**ACTION MEMORANDUM**  
**REMOVAL ACTION**  
**STUDY AREA 50**  
**(WORLD WAR II AIRCRAFT FUEL SYSTEM)**

**FORT DEVENS, MASSACHUSETTS**

Final

RESPONSE TO COMMENTS FROM USEPA REGION I  
ON DRAFT ACTION MEMORANDUM FOR REMOVAL ACTION AT STUDY AREA 50

**FIGURE 3, SAMPLING LOCATIONS AND PROPOSED REMOVAL**

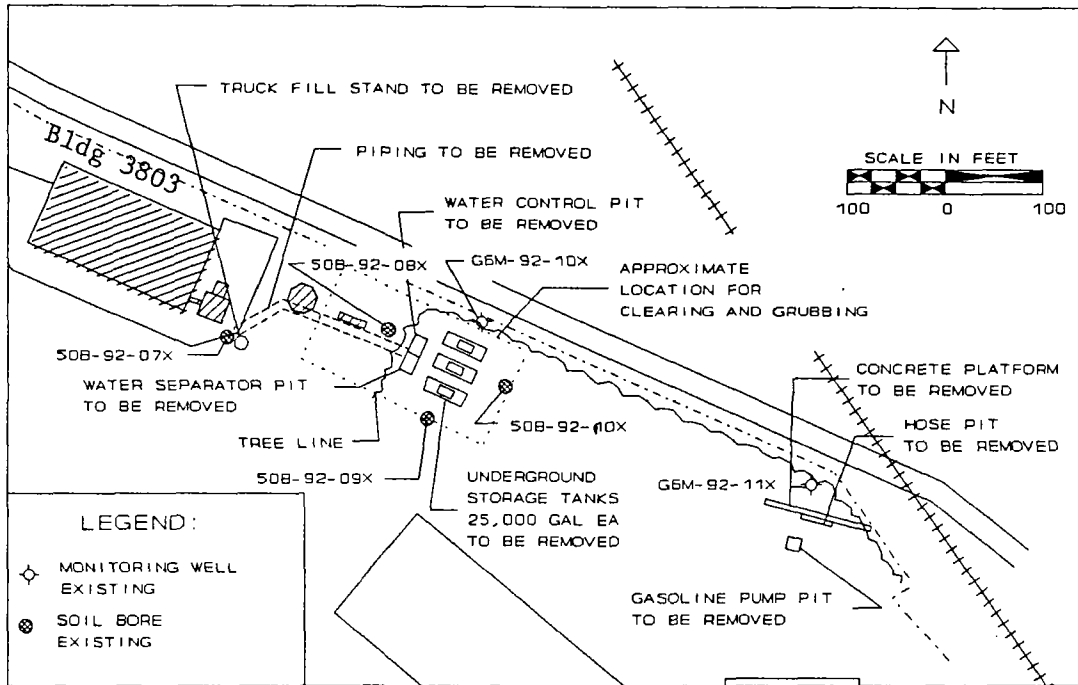
**Comment 2) VI. PROPOSED ACTION, Pgs. 10, 11, & 12:**

Response: Soil sampling in accordance with (IAW) the agreements reached at the November 5, 1992 Underground Storage Tank (UST) Protocol meeting will be performed at all appurtenances (UST lines, water separators, water control pit, truck filling stand, hose pit and gasoline pit). Sampling will be for Total Petroleum Hydrocarbons (TPH, Environmental Protection Agency (EPA) Manual SW-846, Extraction Method 9071, Analysis Method 9073), Benzene, Toluene, Ethylbenzene, and Xylene (BTEX, EPA Manual SW-846, Analysis Method 8020), Methyl tert-butyl ether (MTBE, EPA Manual SW-846, Method 8020), and Lead (EPA Manual SW-846, Analysis method 6010, 7420, or 7421). Numbers of samples and analysis methods will be detailed in the final version of the Action Memorandum.
